Louisville Revitalization Commission

SUBJECT: DOWNTOWN FRONT AND CENTER UPDATE

City Staff will provide an update to the LRC on the revisions and additions made to the Downtown Front & Center concept plan based on LRC feedback provided at the March 25th meeting. The project team has developed a full range of improvement options that can be selected and prioritized to fit within the available project budget in the attached revised concept plans. Presented below is a summary of major comments provided by LRC at the previous meeting and via email and an explanation of how those comments have been incorporated into the revised concept plans:

CITY OF LOUISVILLE FRONT & CENTER PROJECT REVISED CONCEPT PLANS

OVERALL LIGHTING STRATEGY

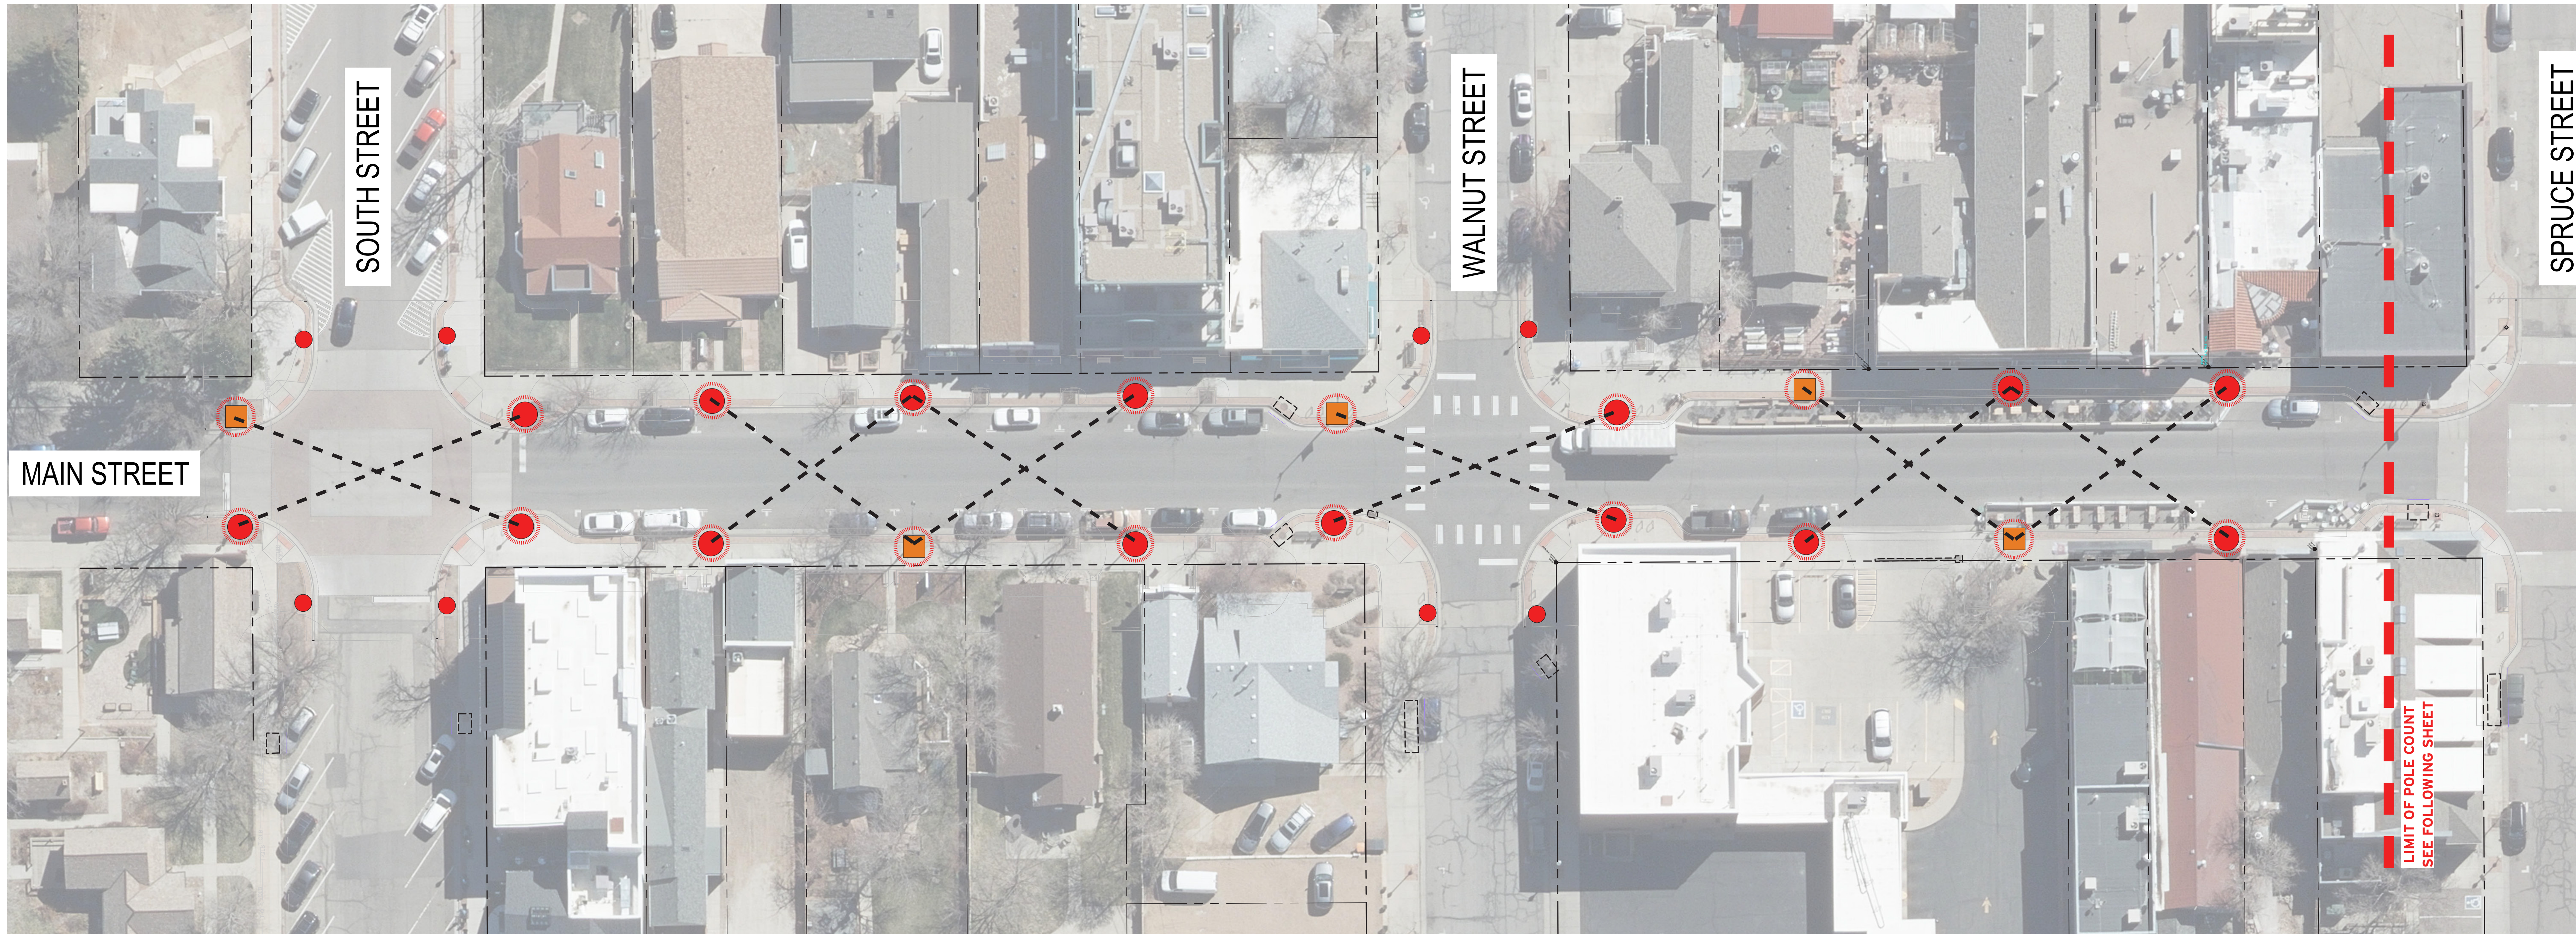
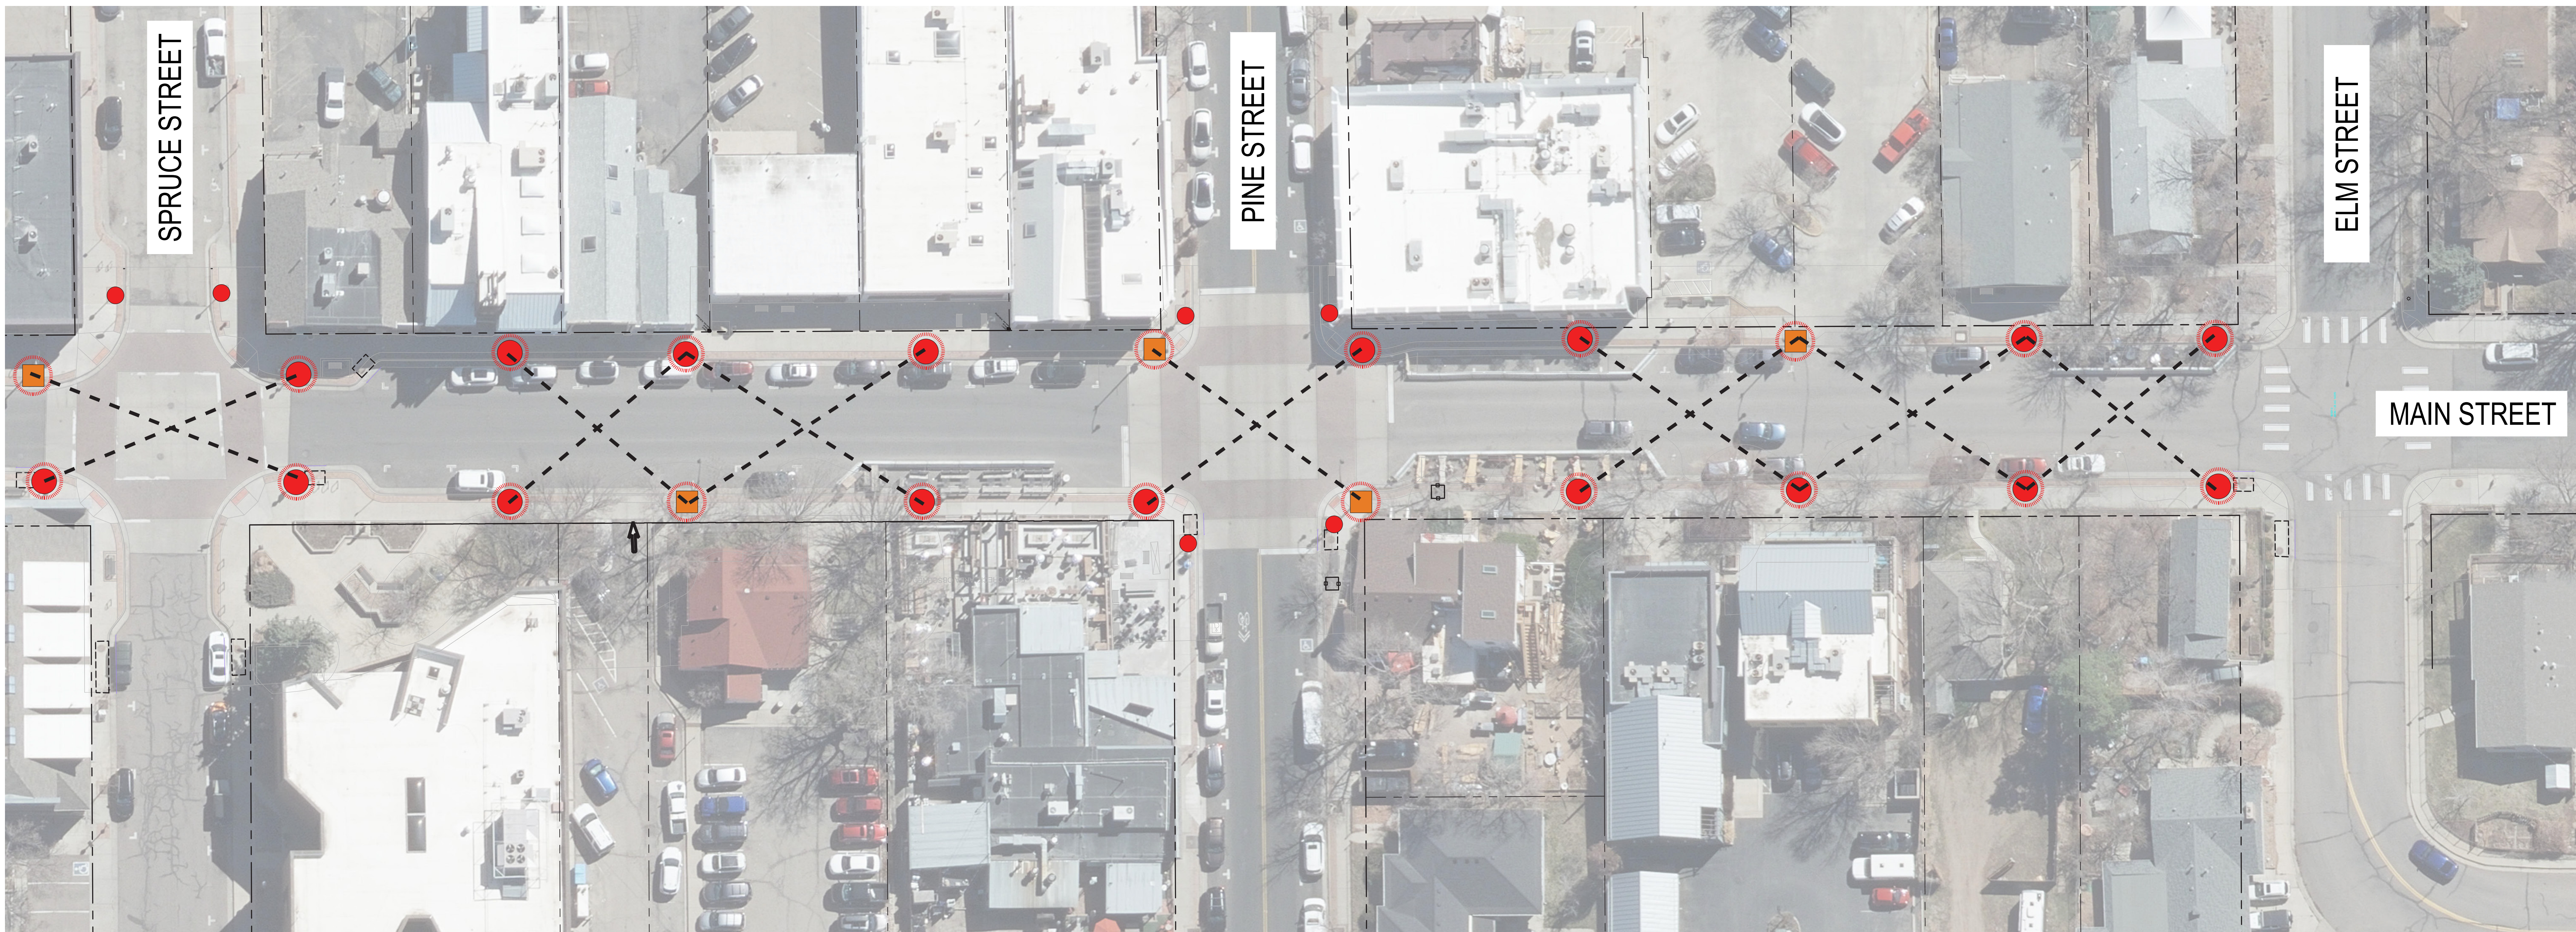
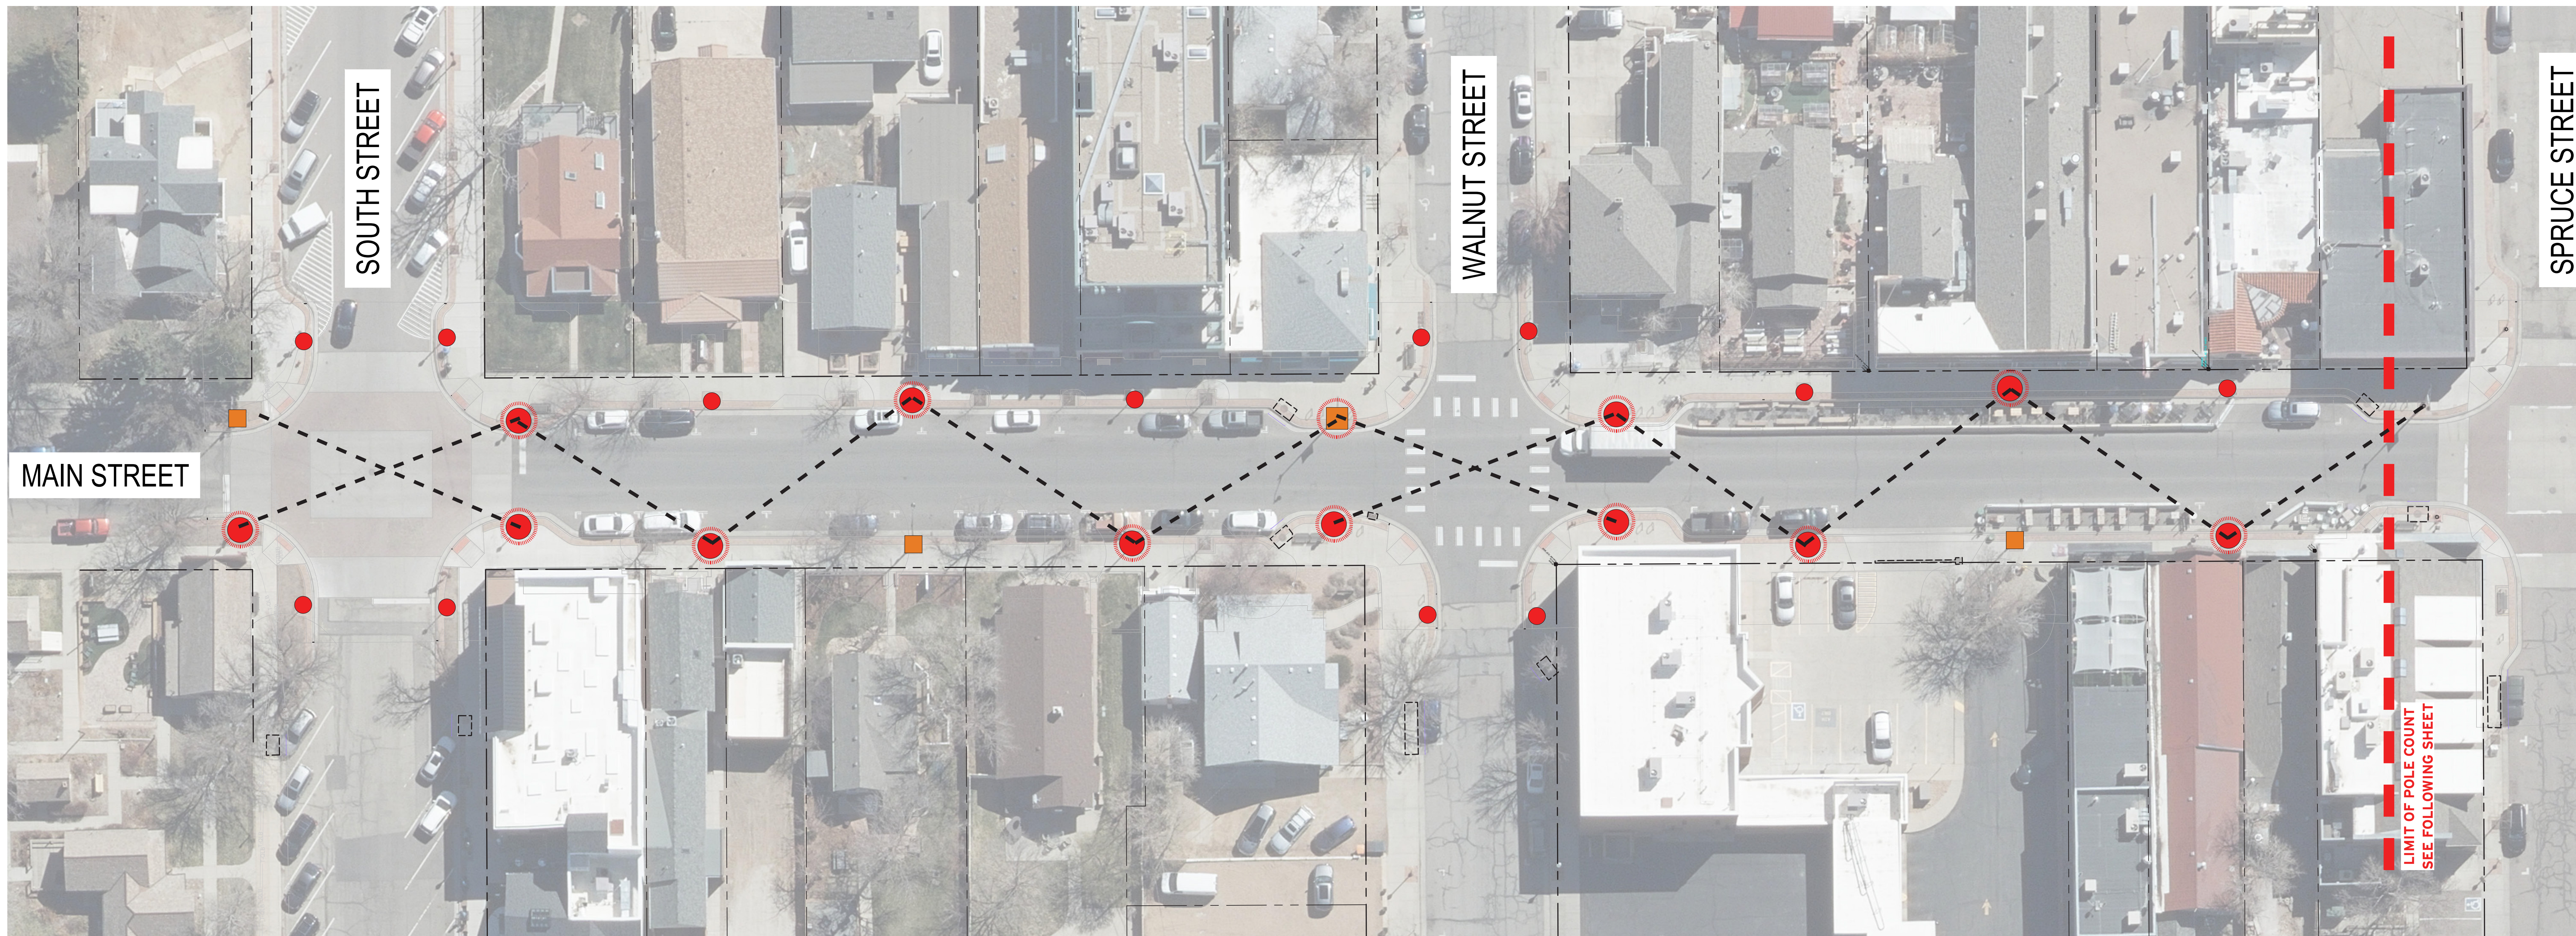
- Provide lighting options extending from South Street to Elm Street.
 - *Two lighting options have been provided for the Main Street corridor, Alternatives A & B. Both alternatives extend from South Street to Elm Street and include the removal and replacement of Xcel-owned poles as required. The City would take ownership of the new the poles. Anticipated costs for Alternative A range from \$1,227,500 to \$1,352,000. Anticipated costs for Alternative B range from \$912,500 to \$1,037,000. Unfortunately, a range of costs must be provided as design must progress further to better understand the electrical distribution costs. Note that these costs do not include intersection lighting costs. Intersection lighting costs are*

anticipated to add an additional \$234,000 - \$334,000 per intersection (or \$1,170,000 - \$1,670,000 for all five intersections).
